**AMENDMENT ON TECHNICAL SPECIFICATION FOR COMPRESSED AIR SYTEM
PACKAGE
5 X 800 MW YADADRI TPS**

SPECIFICATION NO.: PE-TS-417-555-A001

AMENDMENT NO # 1

REV. NO. 00 DATE: 06/08/2018

TITLE	COMPRESSOR HOUSE LAYOUT

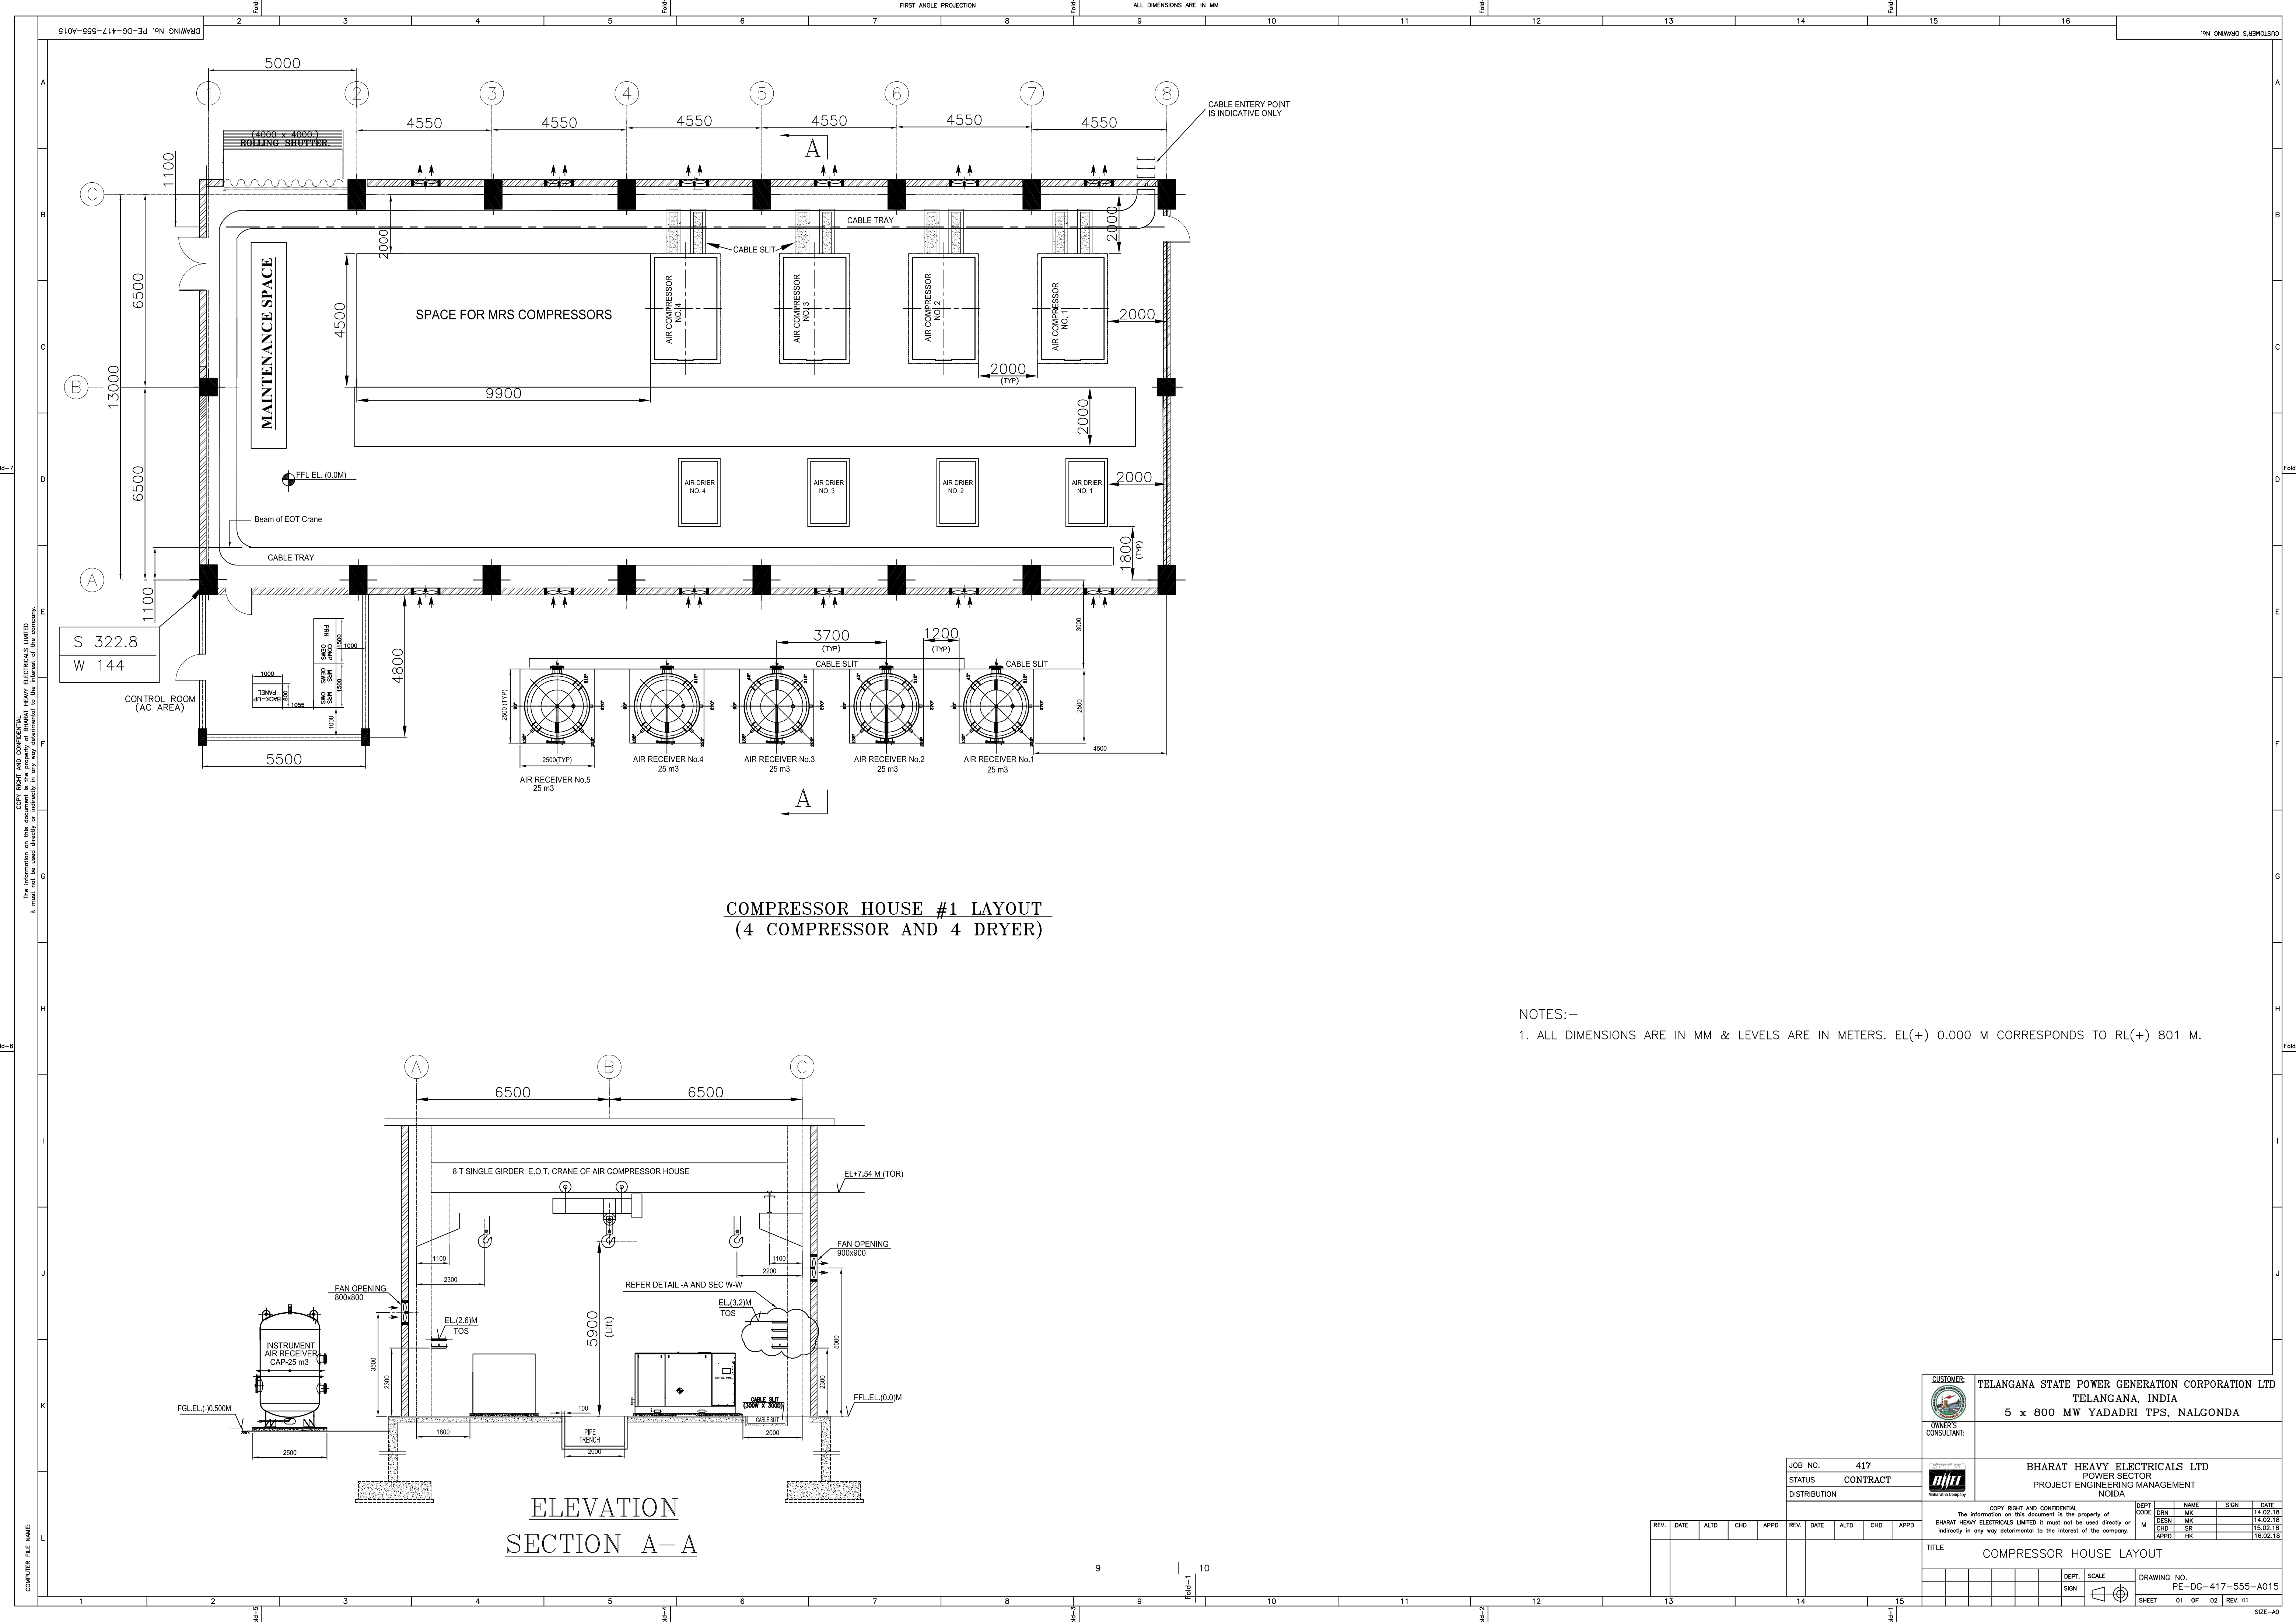
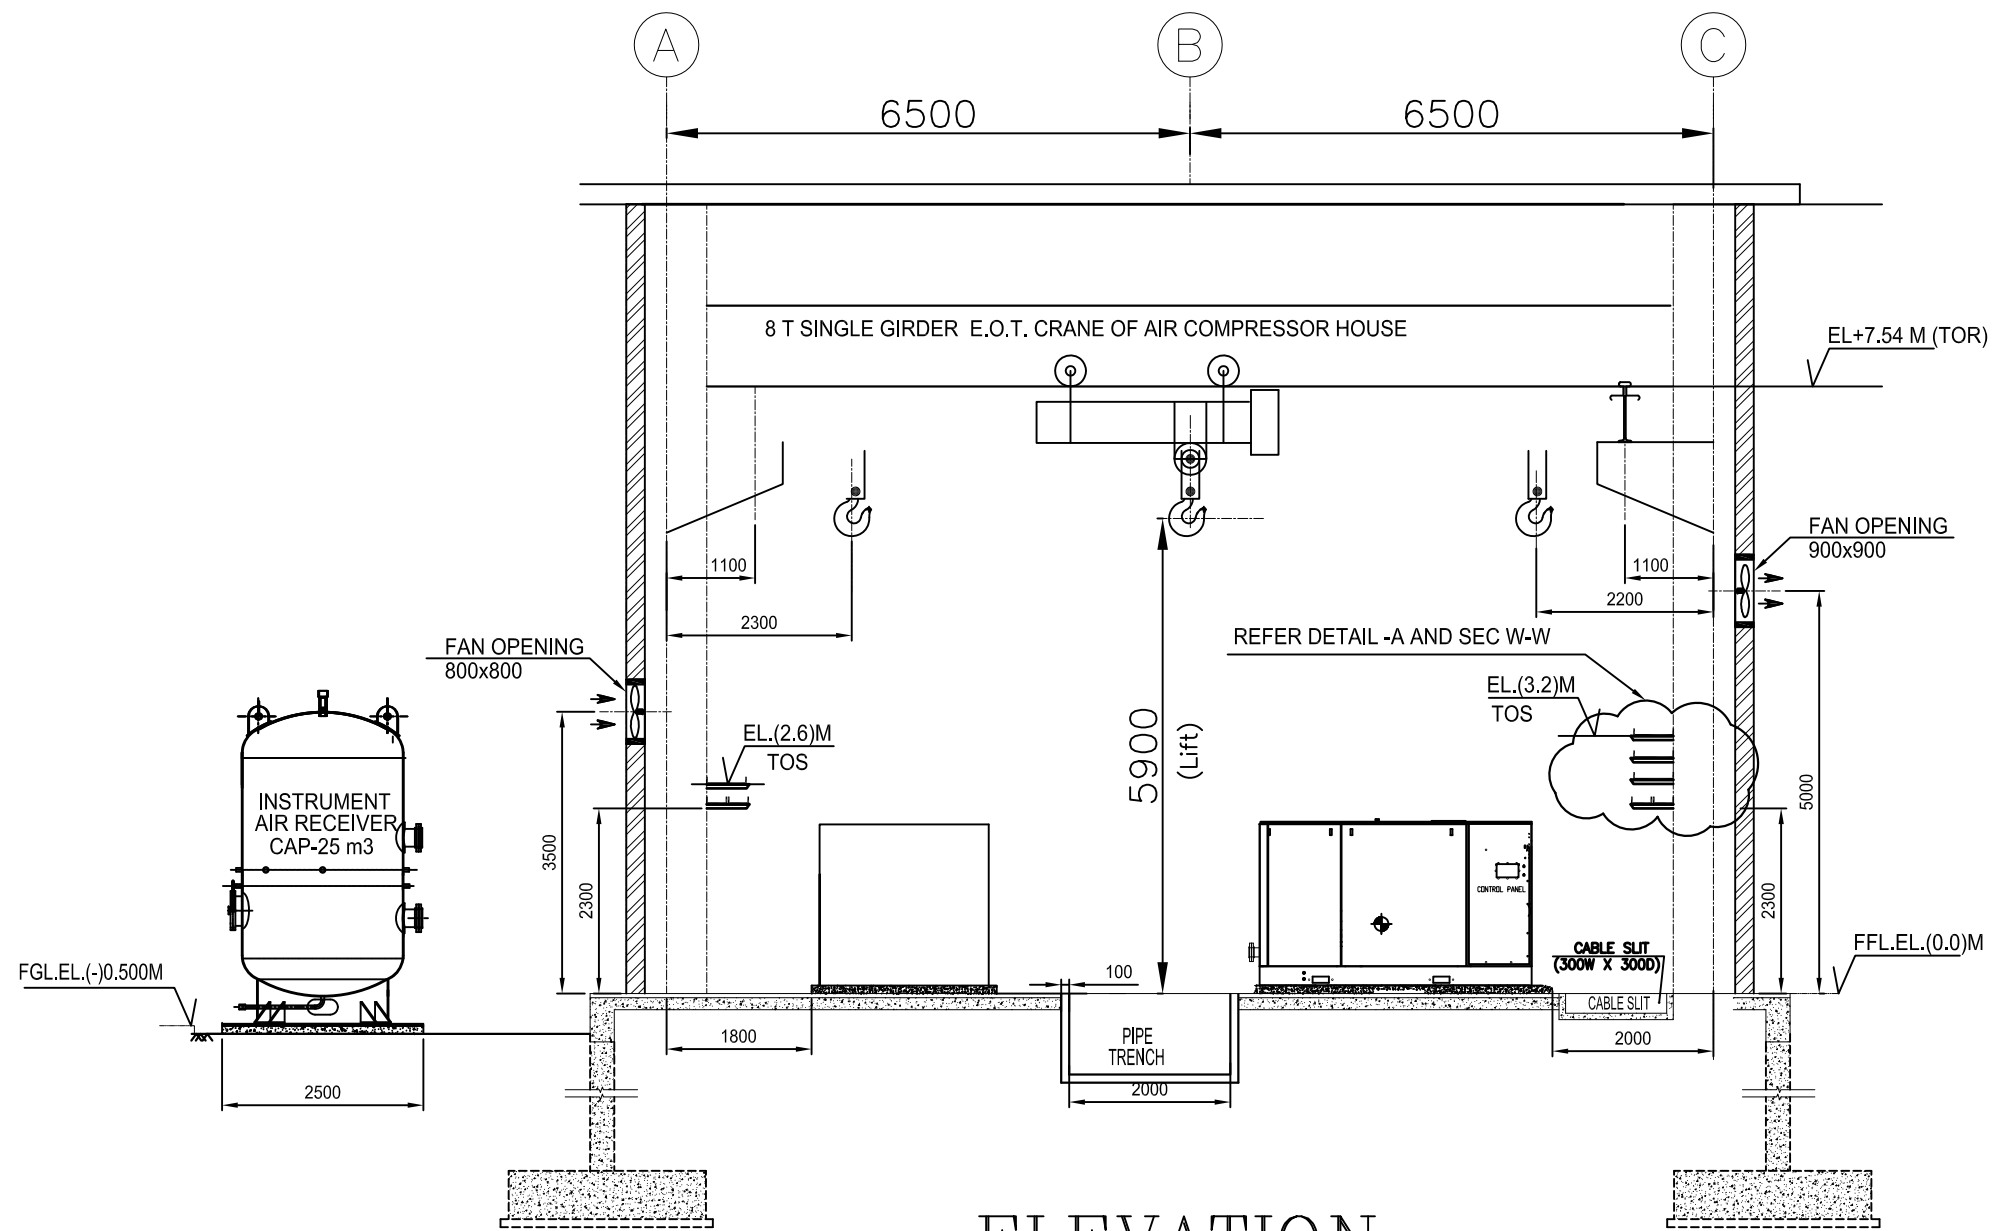
Sl no.	Section	Description	Clause	Page no	Existing clause/details	Modified to or Read as
1.	IA	SEPCIFIC TECHNICAL REQUIREMENT-MECHANICAL	1.1.3	12	10 Nos. Air Receivers (4 nos adjacent to compressor house#1 & 6 nos adjacent to compressor house#2) of minimum 15 (Fifteen) Cu.M capacity each with instruments, relief valve, drain connection with automatic trap stations and other accessories as specified.	17 Nos. Air Receivers (5 nos adjacent to compressor house #1 & 7 nos adjacent to compressor house #2) and 5 Nos unit air receiver (1 no. near each TG building) of minimum 25 (Twenty five) Cu.M capacity each with instruments, relief valve, drain connection with automatic trap stations and other accessories as specified.

2.	IA	ANNEXURE-IV, INPUT DRAWINGS OF TENDER)	--	171-174	drawings 1. P& ID of compressed air system within compressor house (PE-DG-417-555-A018) 2. Compressor house layout (PE-DG-417-555-A015)	Revised drgs. are attached as annexure – A 1. P& ID of compressed air system within compressor house (PE-DG-417-555-A018) 2. Compressor house layout (PE-DG-417-555-A015)
